# UNITED STATES PATENT AND TRADEMARK OFFICE

APPLICATION NO.	FILING DATE	FIRST NAMED INVENTOR	ATTORNEY DOCKET NO.	CONFIRMATION NO.
10/519,280	08/12/2005	Michael Weiss	WET 0127 PCT	8902
7590		07/13/2007		
Robert P Renke Artz & Artz Suite 250 28333 Telegraph Road Southfield, MI 48034			EXAMINER LUONG, VINH	
			ART UNIT 3682	PAPER NUMBER
			MAIL DATE 07/13/2007	DELIVERY MODE PAPER

**Office Action Summary**

FIG. 2

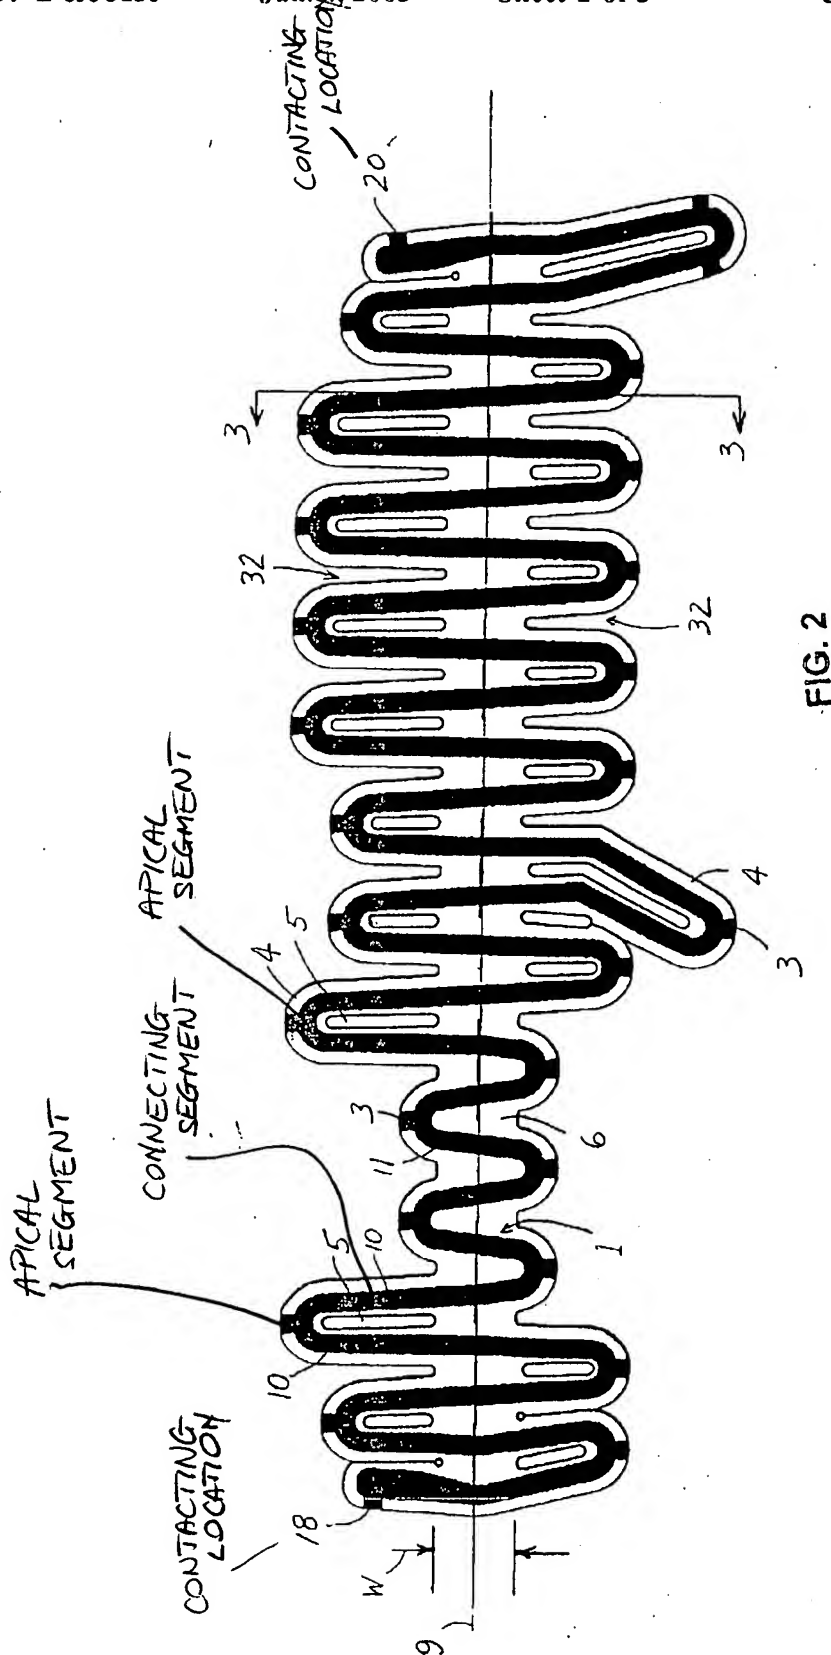
Regarding Claim 1, Nagele teaches a heating element (FIG. 2) comprising an electrically conductive layer 1 with a meandering contour (id. col. 2, line 56+) along a lengthwise direction of the heating element, wherein the heating element is cropped from a substantially continuous segment and wherein the electrically conductive layer 1, at its apical segments (at 4 in FIG. 2,

see Attachment 1 hereinafter "Att. 1"), is widened in each instance compared to a connecting segment (at 10 in FIG. 2, see Att. 1).

Regarding Claim 5, the apical segments (Att. 1) of the electrically conductive layer 1 or the heating element, comprise a rounding radius.

Regarding Claim 6, an envelope 4, 30 (FIG. 3) of the apical segments (Att. 1) arranged on one side of the direction 9 of lengthwise extension of the heating element 1 overlaps (FIG. 2), said apical segments (Att. 1) each remains distanced from each other.
